BULLETIN.016

WELDMATIC 205S: CP102 CP102-11 TRIAC CONTROL PCB

TRIAC CONTROL BOARD CP102-11

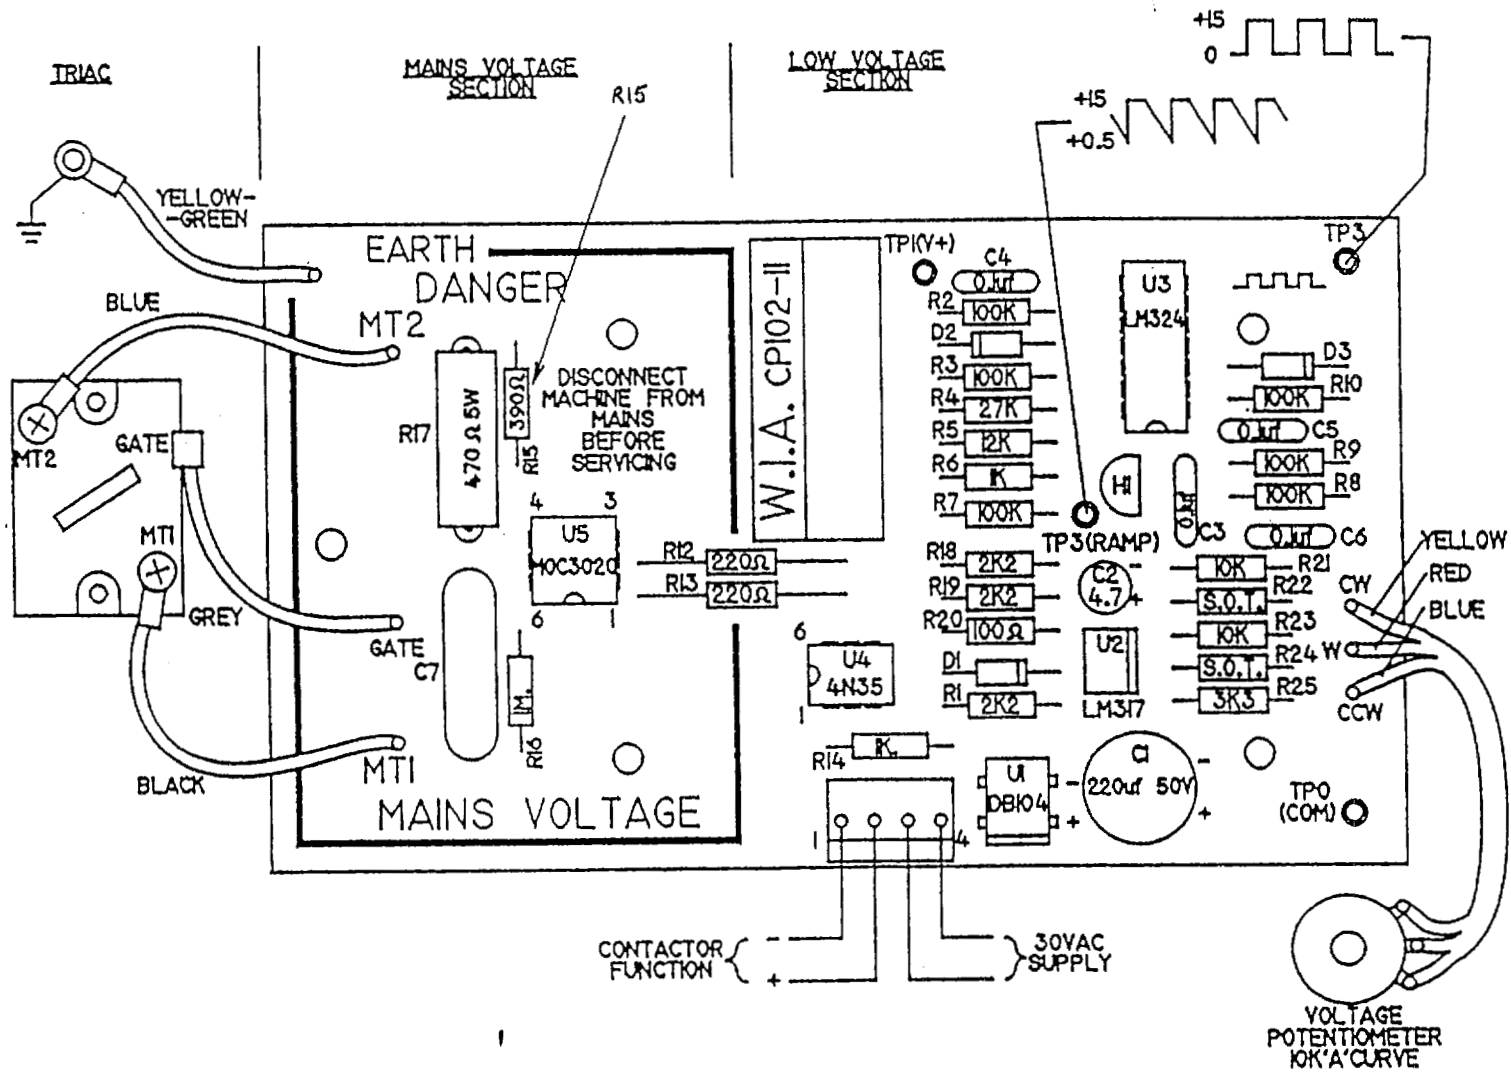
Some early model machines using this PCB, were found to have problems with resistor R15 breaking down, causing no output power.

This resistor has now been replaced with a version that has a higher voltage rating, the part number now being CP102-11/3 (390 Ohm 1W 500V).
